CITY OF CODY
PLANNING, ZONING AND ADJUSTMENT BOARD
TUESDAY, OCTOBER 14, 2014
CITY HALL COUNCIL CHAMBERS

MEETING AGENDA

MEETING DATE:	OCTOBER 14, 2014	TYPE OF ACTION NEEDED	
AGENDA ITEM:		P&Z BOARD APPROVAL:	X
SUBJECT:	SITE PLAN REVIEW: ROD HAYES STORAGE BUILDING/SHOP SPR 2014-24	RECOMMENDATION TO COUNCIL:	
PREPARED BY:	TODD STOWELL, CITY PLANNER	DISCUSSION ONLY:

MEETING DATE:	OCTOBER 14, 2014	TYPE OF ACTION NEEDED	
AGENDA ITEM:		P&Z BOARD APPROVAL:	X
SUBJECT:	SITE PLAN REVIEW: PARK COUNTY SEARCH AND RESCUE BUILDING SPR 2014-37	RECOMMENDATION TO COUNCIL:	
PREPARED BY:	TODD STOWELL, CITY PLANNER	DISCUSSION ONLY:

SITE PLAN

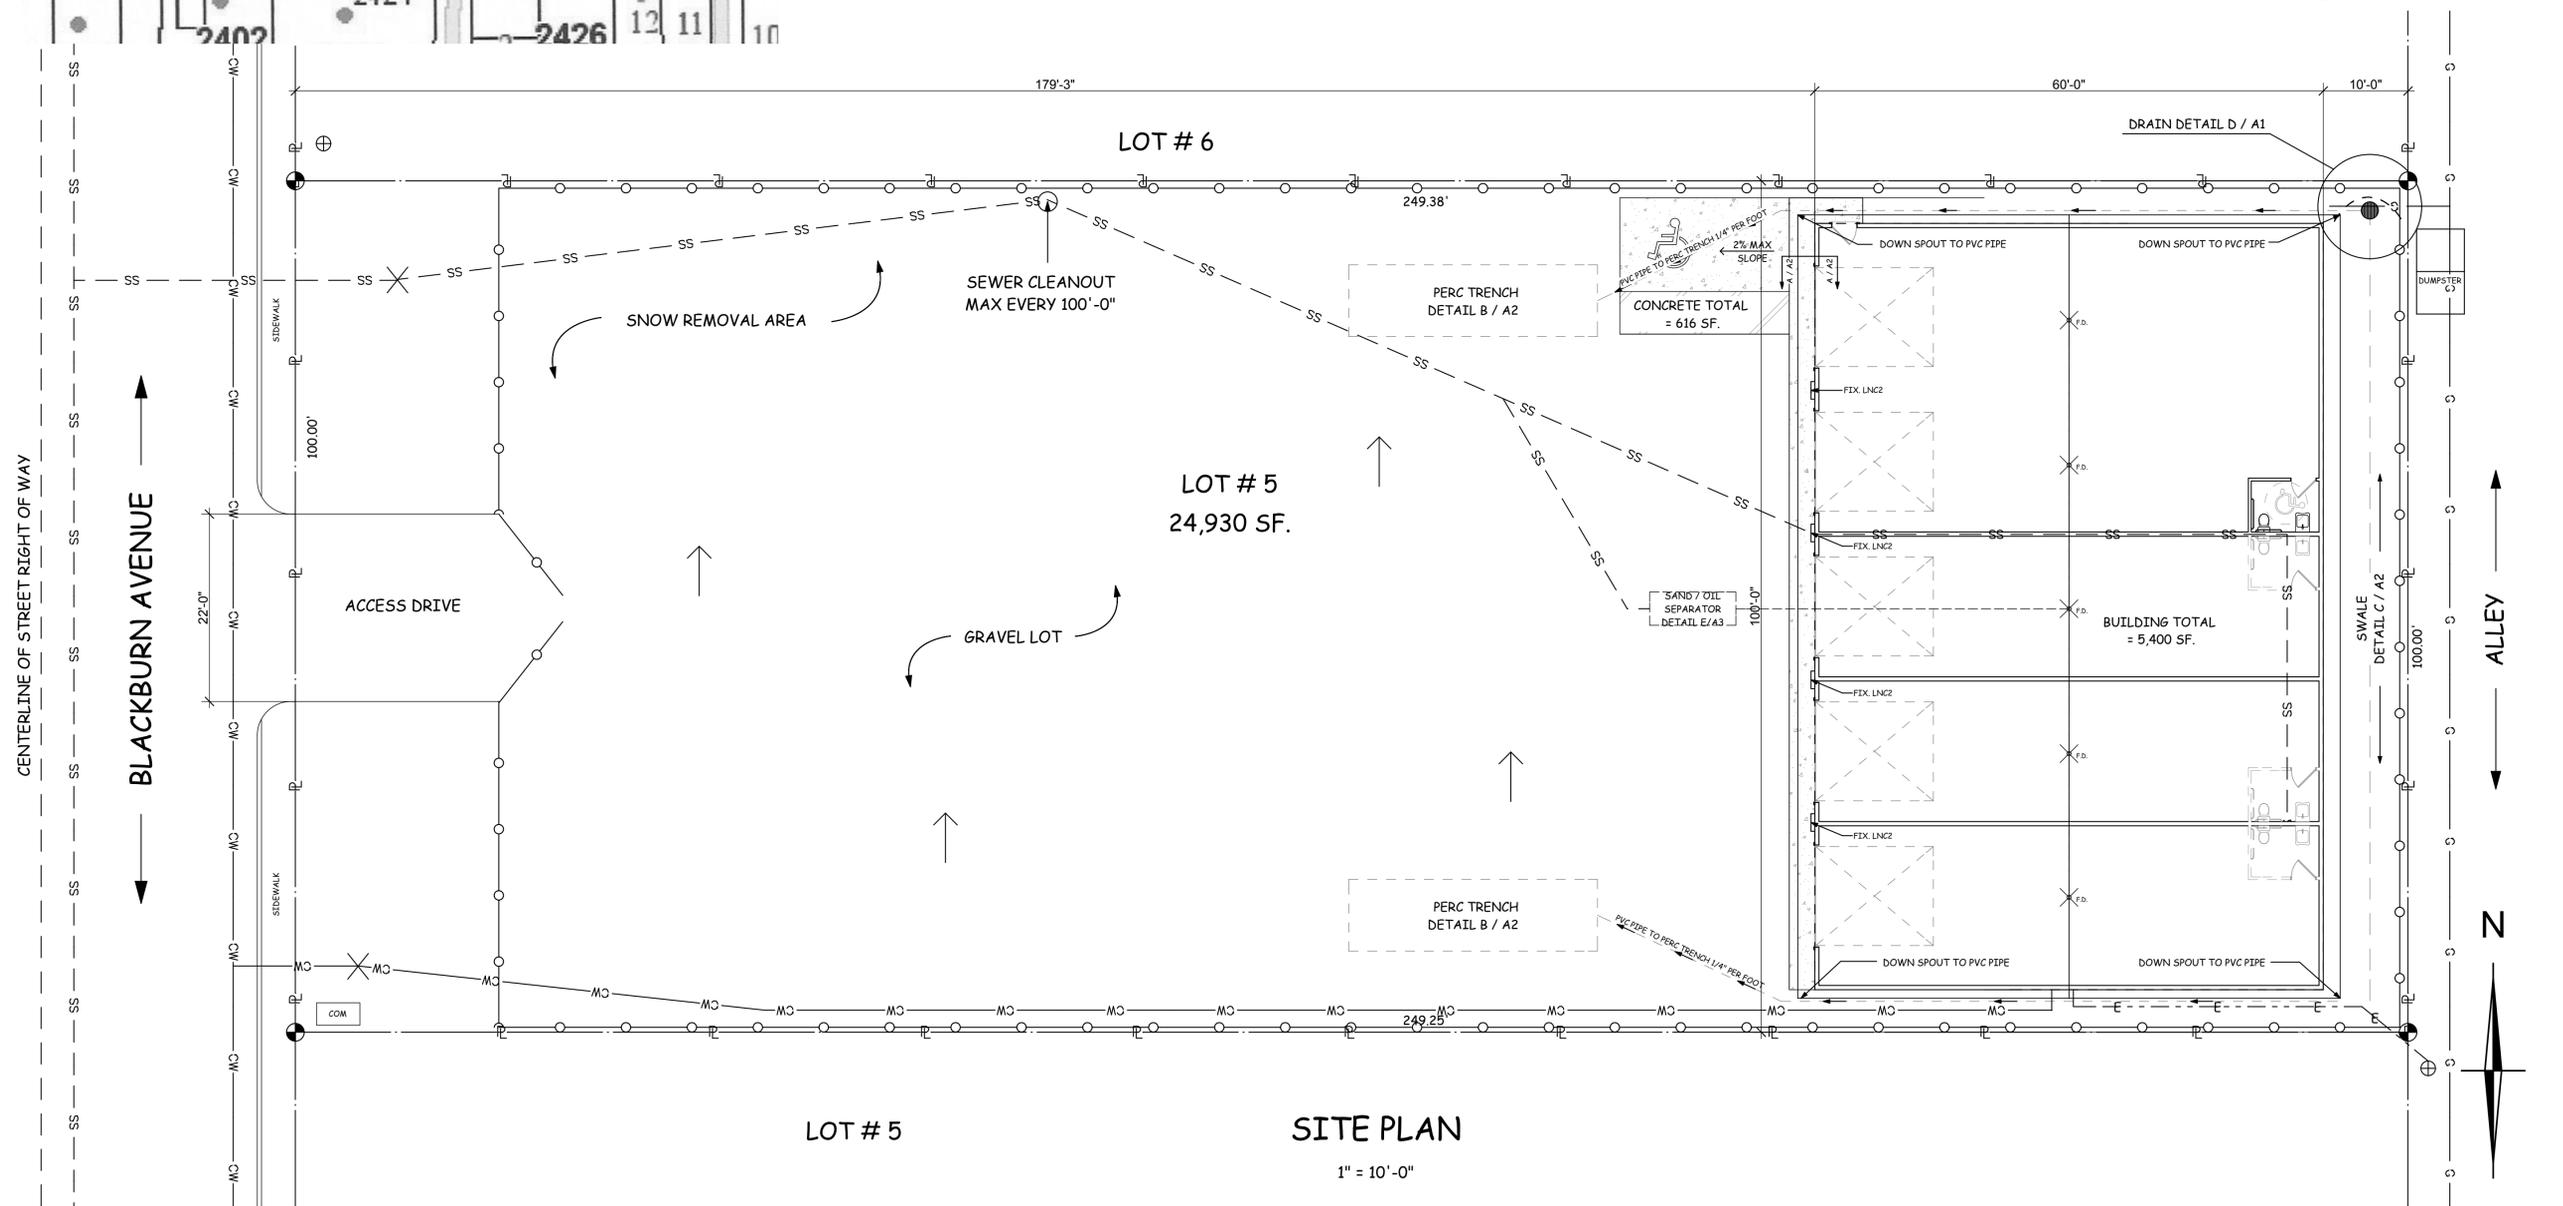
requires six spaces. The large gravel area in front of the building will provide the required parking. A van-accessible ADA parking and loading space is shown as required.

Garbage service is provided by a dumpster in the alley to the east. No garbage collection will occur on Blackburn. Access through the existing fence will be needed (e.g. a gate) to easily get to the dumpster. The applicant may want to add one or more doorways on that side of the building as well.

3. Provide a gate in the fence and a walkable pedestrian pathway for pedestrian access from the building to the alley for access to the dumpster.
4. Prior to occupancy, the applicant's engineer must provide a certification letter that the storm water system was installed in substantial compliance with the storm water plan.

FLOOR PLAN = 5,400 SF.
 SCALE 1/4" = 1'-0"

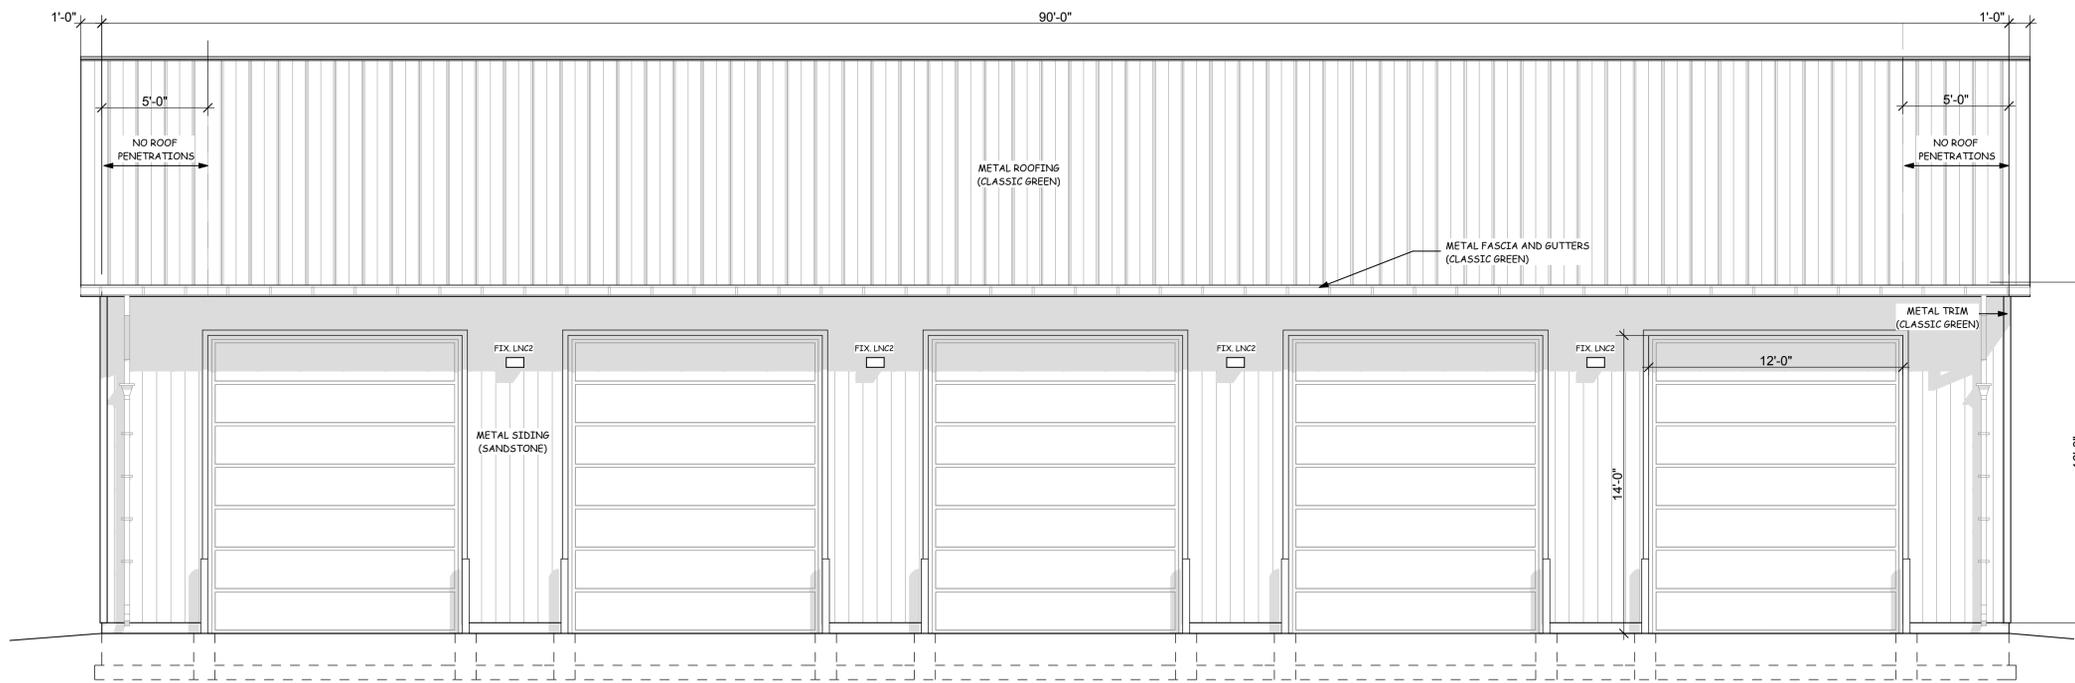
The use and size of the building require that either fire sprinklers be installed, or the building be split into two separate fire areas by a 1-hour firewall from foundation through the attic to the roof sheathing. The applicant plans to use the firewall option, which will need to be added to the plans.

5. Add a sign for the ADA Van Accessible space to the building in front of the parking space.
6. The project must otherwise comply with the submitted site plan and applicable building, fire, and electrical codes, including installation of the required fire separation wall.

SITE PLAN

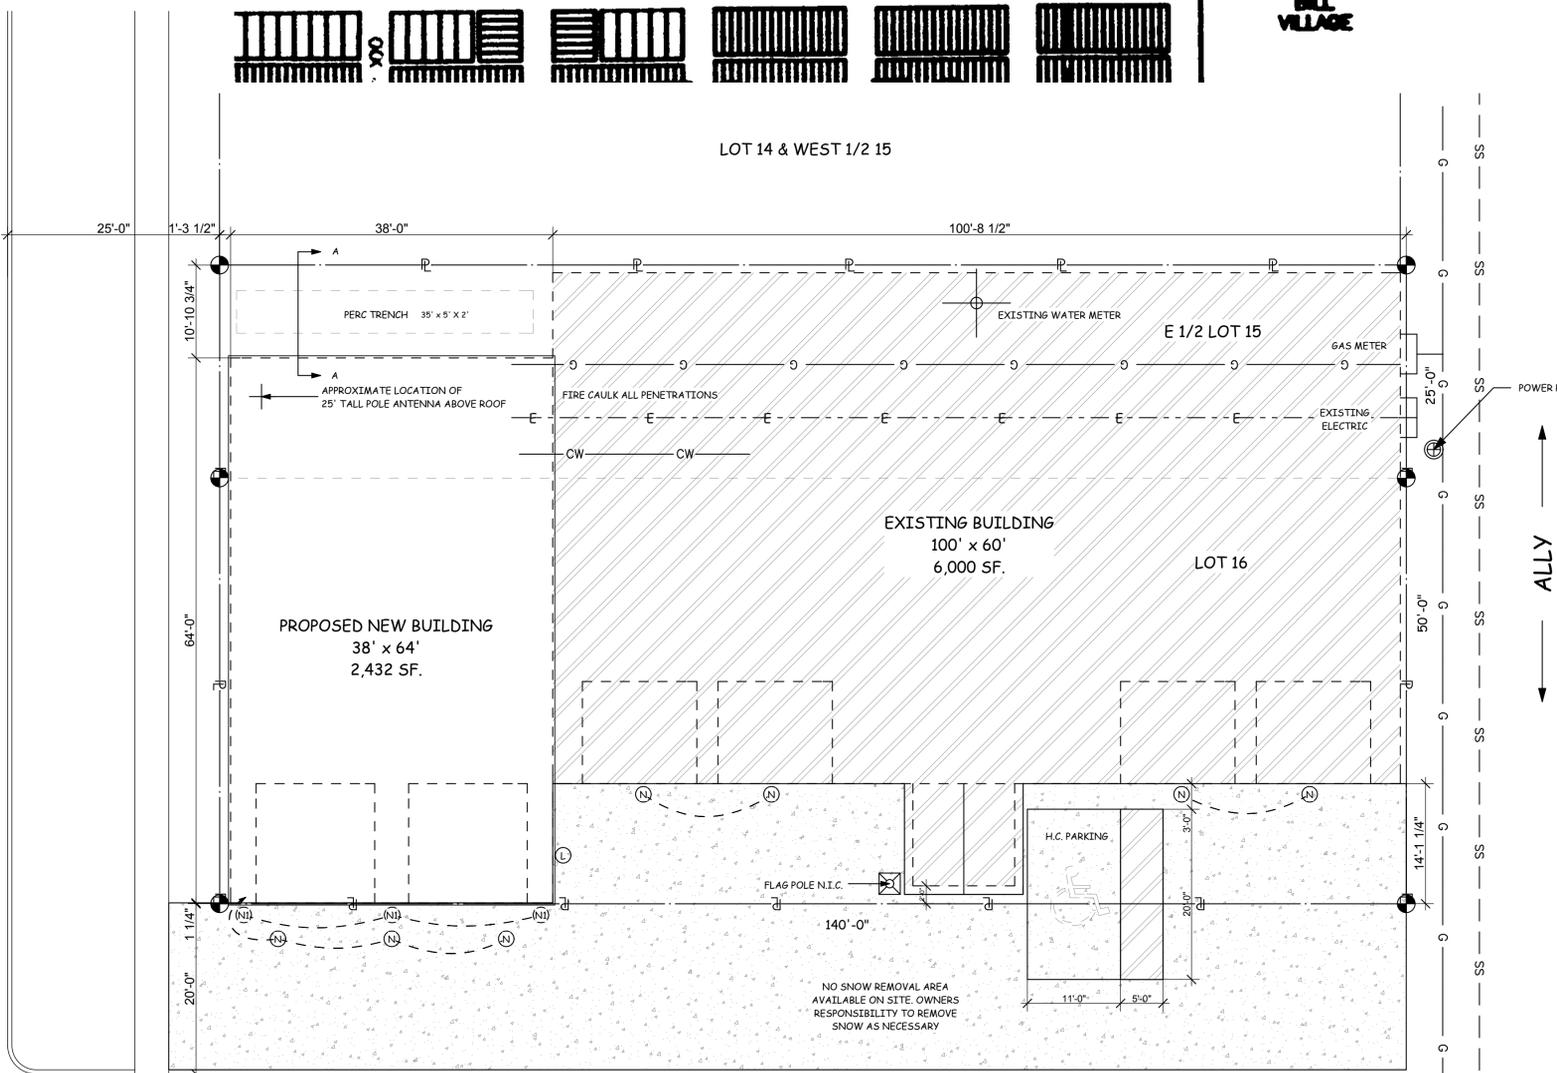
Part of the compatibility factor of the architecture can be addressed by landscaping. No landscaping currently exists or is proposed on the property. However, there is a 13-foot wide park strip between the sidewalk and Salsbury Avenue in which trees could be planted. The trees would help screen the building and visually break up the view of the south wall. Staff recommends that a minimum of two medium trees (25' to 40' height at maturity) or two large trees (over 40' at maturity) be planted in the park strip as part of this project. Tree height at time of planting should be at least 6-8' above the ground. In addition the weeds that currently occupy the park strip should be replaced with groundcover—grass being preferred to match the residential properties along Salsbury Avenue.

There is no snow storage area indicated on the site plan. Being a County facility, they have the resources to haul off the snow if needed, which would satisfy the intent of the requirement. However, this location may not be a priority and snow may be piled on site. The area in front of the existing entrance could be used. The city does not want the snow pushed into the street.

2. That prior to occupancy, the applicant must plant a minimum of two "medium" or "large" trees in the park strip to the south of the property. No tree is to be closer than 30 feet from the corner of the curb at the intersection and the tree species and location must be authorized by the city in accordance with City of Cody Code 7-4. In addition, the park strip is to be provided with a finished groundcover to prevent weeds, such as lawn or decorative rock.

FLOOR PLAN BUILDING # 2

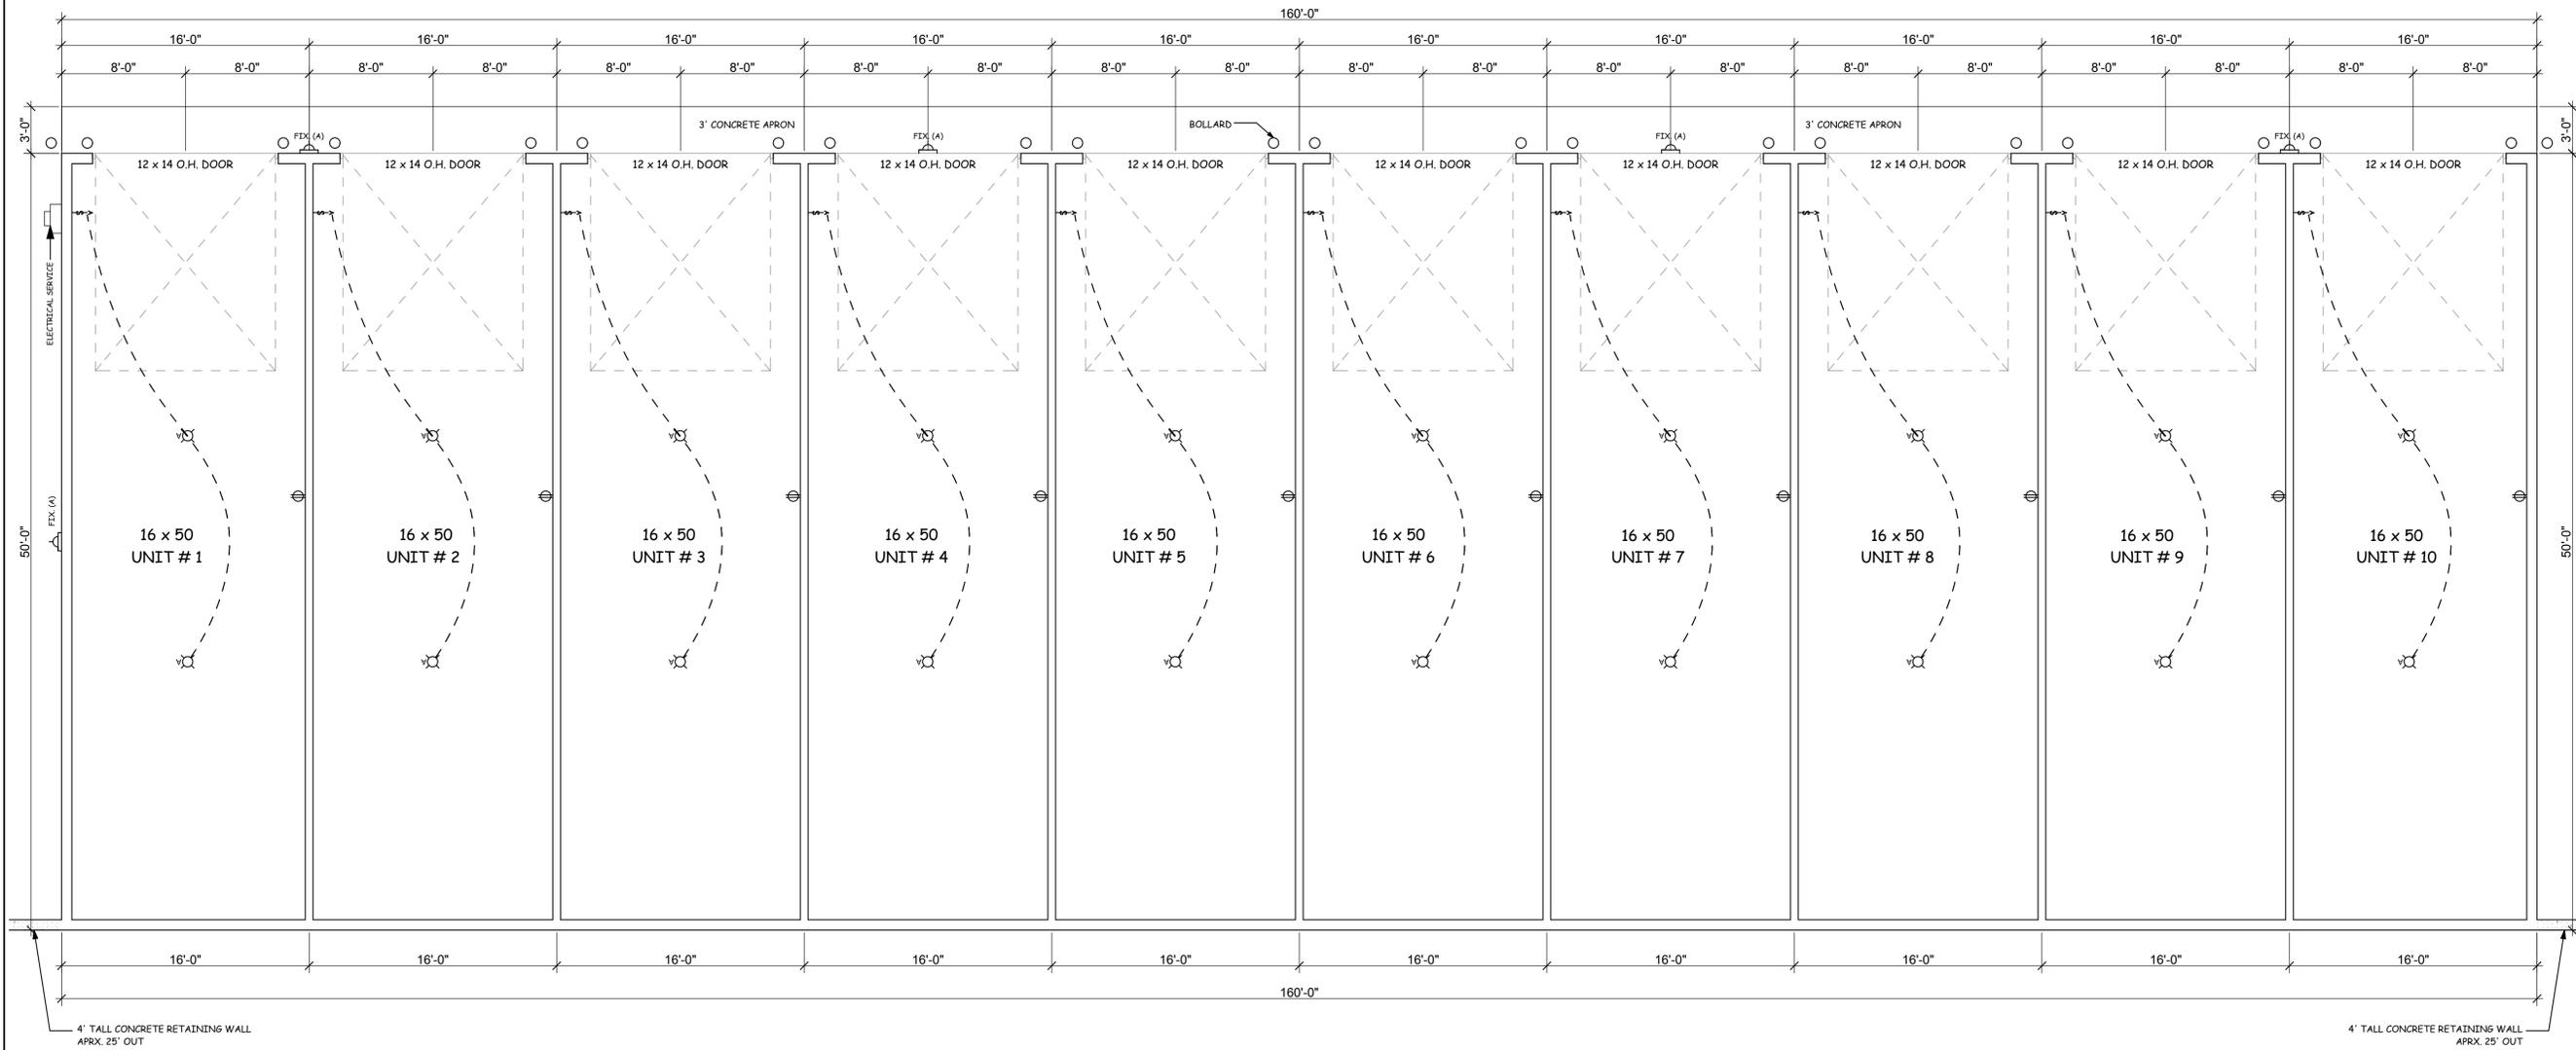
A fire wall separation is required within the building in order to avoid the requirement for a fire sprinkler system. The building plans will need to reflect the fire wall separation.
